**Subject: MHI's Responses to US-APWR DCD RAI No. 751-5709 Revision 0
(SRP 06.02.05)**

US-APWR Design Certification

RAI NO.: NO. 751-5709 REVISION 0
SRP SECTION: 06.02.05 – Combustible Gas Control in Containment
APPLICATION SECTION: 6.2.5
DATE OF RAI ISSUE: 5/2/2011

QUESTION NO. : 06.02.05-43

Figure 6.2.5-43-1 Dry Hydrogen Concentration for SBO Scenario

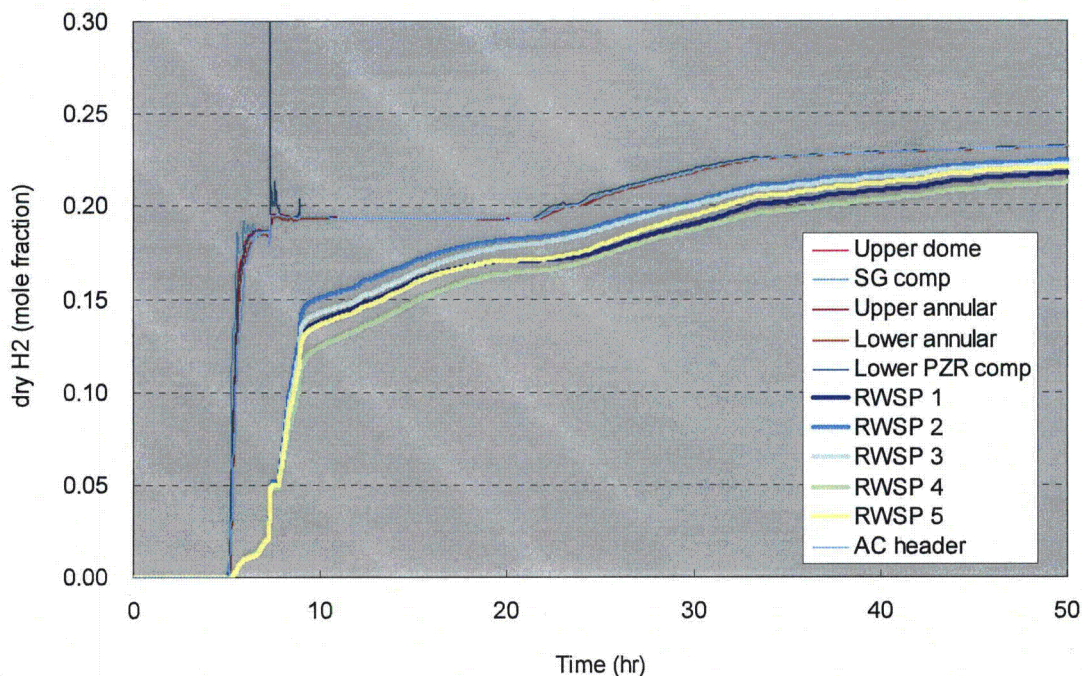
In regard to the Hydrogen monitor, since it is established that there is potential to have hydrogen concentration in the RWSP that is different from the rest of containment, please provide additional details of the US-APWR hydrogen monitoring system that allows monitoring of this compartment. In accordance with 50.44(c)(4)ii. Please also discuss compliance with Regulatory Guide 1.97, regulatory position 5. Revise section 6.2.5 of the DCD as necessary to record these design commitments for these components.

The hydrogen concentration presented in Figure 19-449-6 of RAI #627-4926 Question 19-499, which was calculated for a SBO with RCP seal LOCA scenario, is manipulated to observe the dry hydrogen concentration as shown in Figure 6.2.5-43-1 below. The dry hydrogen concentration is a hypothetical value assuming that steam does not exist in the air. Time zero is the initiation of RCP seal LOCA (assumed simultaneously occurring with SBO) and core melt occurs at approximately 5 hours. At that time, hydrogen is released to the containment compartment. It can be observed from this figure that the hydrogen concentration in the RWSP gradually increases when the containment atmosphere containing hydrogen and steam flows into the RWSP, although the dry hydrogen concentration in the RWSP is always lower than that in other compartments.

It can be considered from this evaluation result that the overall level of atmospheric mixing in the containment (including the RWSP) is still high even when the CSS is not available. This high level of mixing is the cause of the high RWSP hydrogen concentration because it allows a constant and continuous replenishment of the flow into the RWSP (due to condensation of the steam-rich atmosphere by the sub-cooled RWSP water).

It should be noted that the accident scenario shown in Figure 6.2.5-43-1 considers an extremely conservative assumption, which is the RCP seal LOCA from all four RCPs with a 300gpm leak immediately after SBO. In reality, it is more likely that the seal leak rate is less than this assumption so that longer time may be available for recovery action for various mitigation systems before core damage. Initiation of firewater injection may be determined when these recovery actions have all failed and core damage is highly anticipated or has already been identified.
